V2500 A1/A5 SERIES PROPULSION SYSTEM NON-MODIFICATION SERVICE BULLETIN

This document transmits Revision 1 to Service Bulletin EV2500-72-0500 and Revision 1 to the Supplement

# NON-MODIFICATION SERVICE BULLETIN - N2 VIBRATION MONITORING FOR THE HIGH PRESSURE TURBINE (HPT) STAGE 2 AIR SEAL

Typical Plot for N2 Vibration Data Analysis Figure 1

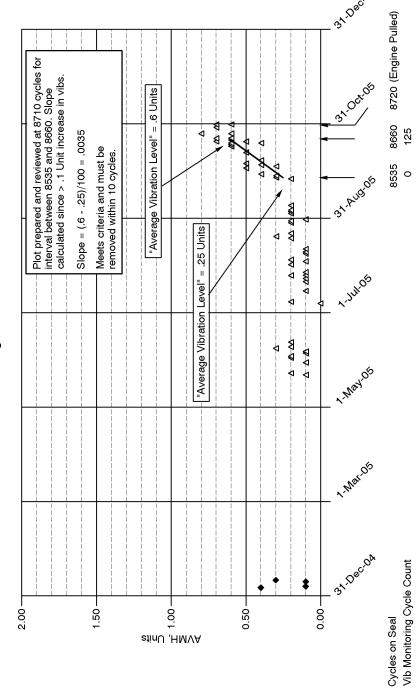
R		(a) Determine 'average vibration level' at the first point of the line.	
R		(b) Determine 'average vibration level' at the end point of the line.	
R R R		(c) Using engine or Aircraft records, determine engine cycles corresponding to the first and last points of the line. Calculate slope:	
R		Slope = Change in 'average vibration level' / Change in engine cycles.	
R R		NOTE: Figure 1 shows a typical vibration plot, the 'average vibration level' and how to calculate the slope.	
R	(5)	Take action as follows:	
R		(a) Slope less than .001 Units/Cycle:	
R R R		(i) The HPT Stage 2 Airseal is not suspect of being cracked - the engine can remain in service and vibration monitoring should continue.	
R		(b) Slope is .001 Units/Cycle or greater and less than .003 Units/Cycle:	
R R R		(i) The HPT Stage 2 Airseal is suspect of being cracked and the engine needs to be removed within 250 total cycles from when the slope began to increase.

All operators are to establish a process for monitoring AVMH levels focused on identifying an increasing AVMH trend described in Figure 1. Only observed N2 vibration values should be used for plotting purposes.
